FARRAGUT VISUAL RESOURCES REVIEW BOARD AGENDA

a) Phase II (Commercial Area) of The Town Center at Biddle Farms Development, Revised Plan - Located off Kingston Pike and Brooklawn Street

Revised Landscape plan for Phase II (commercial area) of the Town Center at Biddle Farms Development.

This item involves a revised landscape plan for the commercial, Phase II, section of the Biddle Farms development. It includes both as-built landscape updates and proposed revisions and is primarily shown on plan sheets L2.1, L2.2, and L2.3.

Landscape Plan - Phase II - Bldgs B, C, D, & E
Farragut Town Center at Biddle Farms
105 - 146 Biddle Farms Boulevard and 112 - 116 Brooklawn Street
CLT Map 143, Parcel 3.02
Town of Farragut, Tennessee 37934

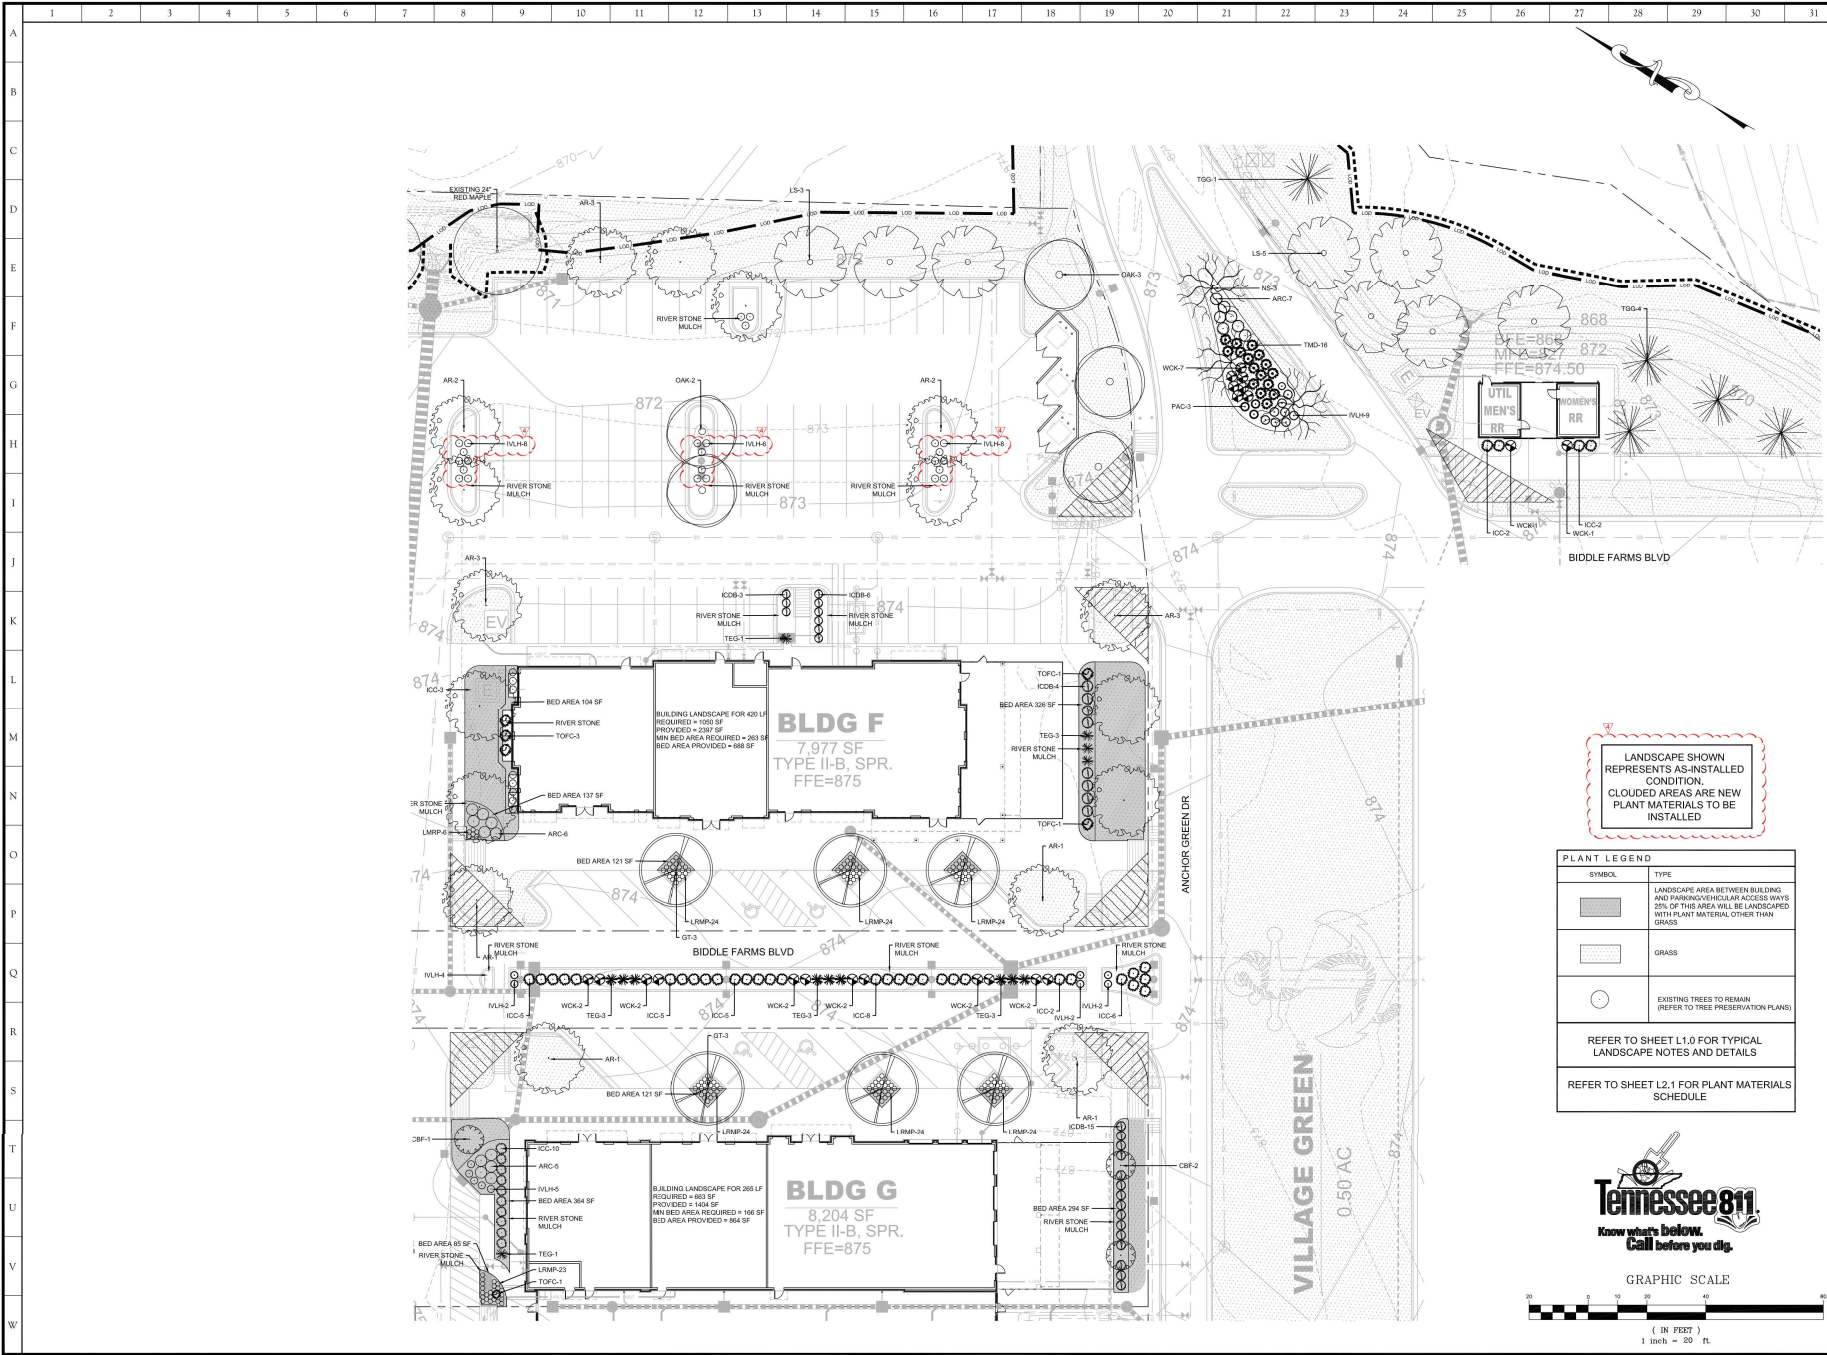
The revised plan has been submitted for several reasons. First, to document plant species substitutions and additional plantings made on site since the last plan was reviewed by the Board. Second, to request the Board's approval for the use of landscape stone within a number of parking lot islands and landscape strips, along with some required landscape areas between the buildings and parking lot areas. And third, to propose several additional revisions/additions to the plan and existing plantings on site. Some of these proposed additions/revisions relate to and are intended to soften the use of landscape stone in some areas.

From the staff's perspective, the documented and requested species substitutions or additions are appropriate and meet the Town's requirements, provided the applicants

can document that the variety of Nandina used is a non-invasive one. The staff can recommend approval of these subject to the noted Nandina being non-invasive.

The Board will need to discuss this at the meeting to determine if the use of the stone enhances the overall design and if additional planting may be needed to soften its appearance. The staff suggests that Board members visit the site individually before the meeting if at all possible. For those members who are able to visit, please consider that some of the existing plantings have not reached their mature size and visual effect. Please also refer to the applicable plan sheets (L2.1, L2.2, L2.3), which generally attempt to show the approximate size/spread of the plantings at maturity.
